TRANSPORT DOCUMENT REVIEW
The Porcupine Inn, Mottingham

Prepared for: London Borough of Bromley
Ref: HH4200317/DK/003
Issue 3: 31 July 2020

- 1.1 Glanville were appointed by the London Borough of Bromley, to provide an independent review of the transport information provided in support of the planning application for the re-development of the former Porcupine Inn in Mottingham into a new Lidl food store. The site is located on the B266 Mottingham Road in Mottingham, within the London Borough (LB) of Bromley.
- 1.2 The LB Bromley planning application reference is 19/01670/FULL1.
- 1.3 The development proposals involve the demolition of the existing 324sqm public house and the construction of a 1,352sqm food store with associated 33 space car park. Vehicular access will be achieved via an improved site access off Mottingham Road, located around 30m east of the War Memorial roundabout.

Image 1– Areas of concern with the HGV Turning within the Car Park

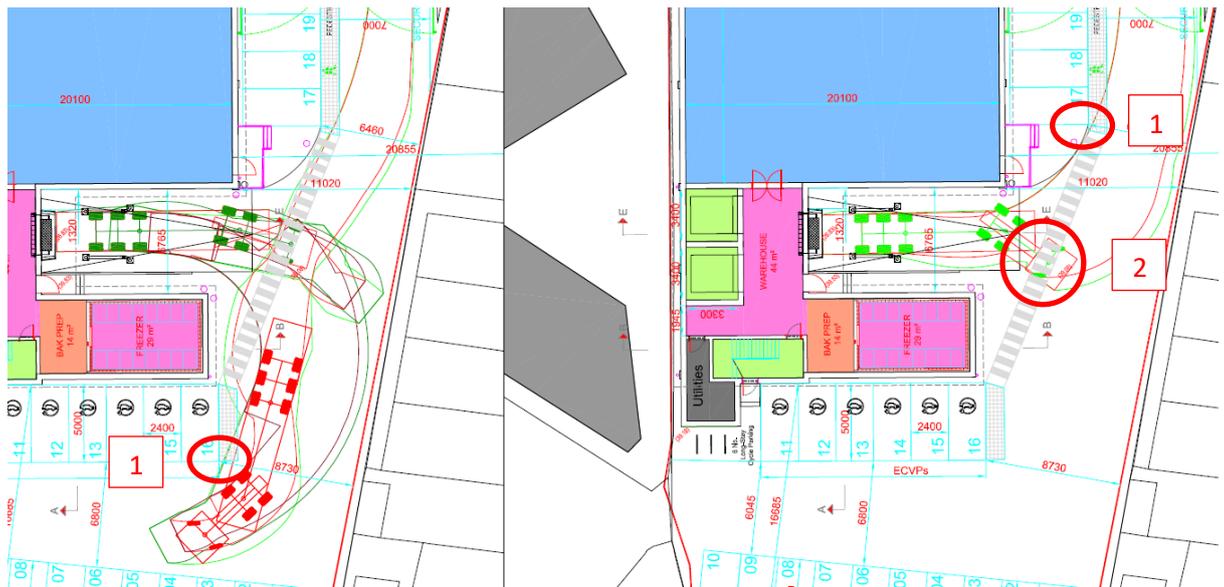
- c) The swept path of the delivery vehicle shows that the manoeuvre when accessing the loading bay is achievable although relatively tight in places. Typical sized cars will be able to fit within the bays with clearance to the bay edges, however if large cars are parked in spaces 16 and 17 then this may increase the potential for the vehicles being clipped by the delivery vehicle. Similarly, large cars are sometimes longer than 5m and therefore often stick out of the end of a parking bay which may increase the risk of large vehicles being clipped by the HGV (see points 1 within Image 1). For space 17, however, it appears that there is a bollard adjacent to the space which provides protection for the parked vehicle. It should also be noted that the tracking software provides a worst case swept path and therefore in real life, the vehicle movements tend to be better than that shown by the swept path software; and

- d) When reversing into and when parked within the loading bay, the delivery vehicle blocks the pedestrian desire line and the marked pedestrian route between the store entrance and the rear of the car park (see point 2 in Image 1).

- 3.16 It is understood that one of the reasons for refusal of the previous appeal was that an HGV, when manoeuvring into the loading bay, would encroach the adjacent parking bays. Whilst the HGV swept paths are relatively tight, the swept paths do show that it is possible to turn the HGV without encroaching into the bays and therefore responds to the Inspector’s concerns about having to block off parking spaces during deliveries. Similarly, it is important to note that delivery drivers are highly trained and regularly make deliveries within operational car parks and are therefore experienced at manoeuvring within confined areas amongst pedestrians.

- 3.17 With respect to Glanville’s concerns about pedestrian movements during the store delivery times, the Delivery, Servicing and Waste Management Plan (see Chapter 4) identifies that the delivery vehicles have an audible and white noise warning system to make pedestrians aware of reversing vehicles. As outlined in paragraph 3.16, it is considered that delivery drivers are used to servicing stores within car parks and are therefore fully aware of pedestrian movements. It should also be noted that vehicles will be moving slowly within the car park and therefore it is considered that the risk to pedestrians is reduced.

- 3.18 Based on the above concerns it is considered that the servicing of the store is a typical arrangement throughout the country and therefore drivers are fully aware of the risks when manoeuvring. The swept path information provided shows that vehicles are able to manoeuvre within the car park and the delivery arrangements are therefore considered to

be acceptable. **If LB Bromley have continued concerns about the servicing arrangements, then consideration could be given to using smaller delivery vehicles or restricting delivery to outside of peak shopping times.** It should be noted, however, that using smaller vehicles is likely to increase the number of daily deliveries required.
